TOWNSHIP OF WEST ORANGE

TO: Zoning Board Members

RE: **ZB 23-11 / De Oliveira**
Block: 55.06; Lot: 1.01; Zone: R-5
31 Bradford Avenue
Seeking “c” variance approvals for retaining walls and fences

Fence atop rear yard retaining wall

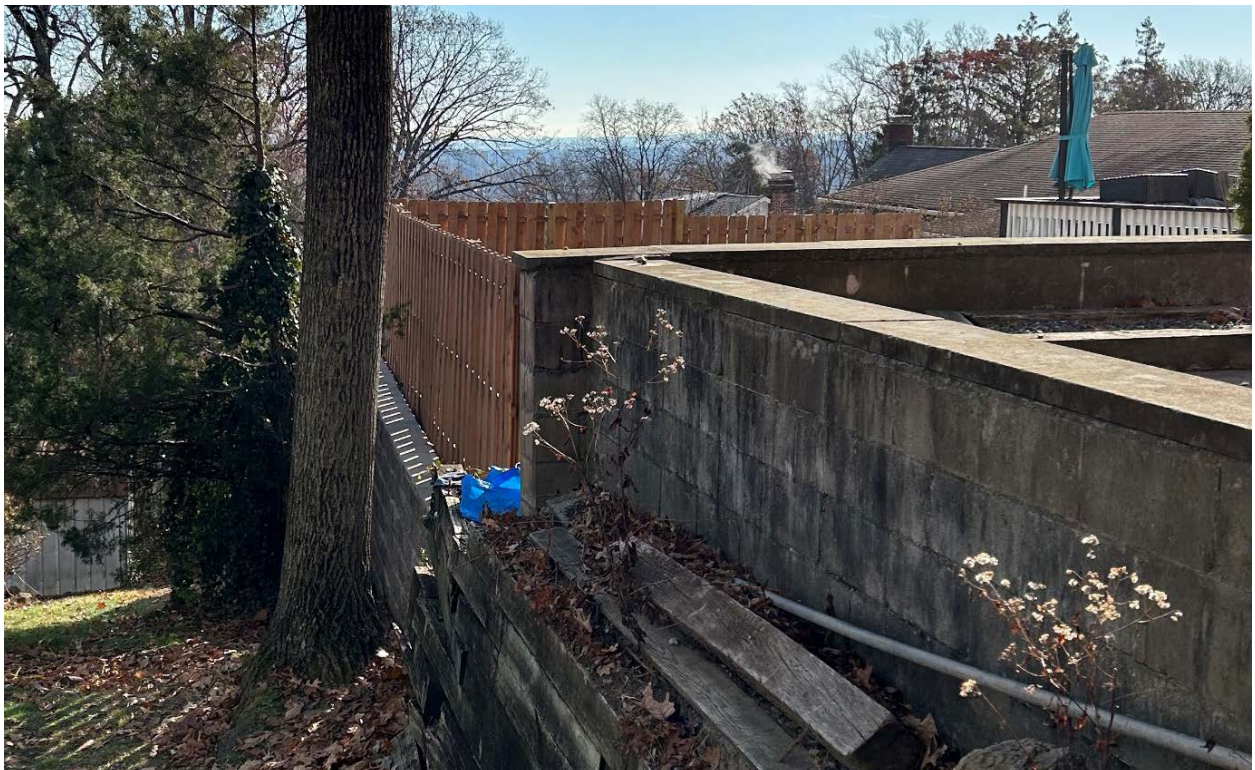
The application indicates there was previously a railroad tie retaining wall on the lot that failed, and that the new walls are necessary due to the site's topography. Testimony should be provided regarding this information and the history of the construction of the walls and fences.

It is noted that the submitted plans show the constructed wall encroaching on an adjacent property (Block: 55.06, Lot 2.01). The applicant should provide additional information regarding this encroachment and whether the adjoining property owner provided permission for the construction of the wall on Lot 2.01.
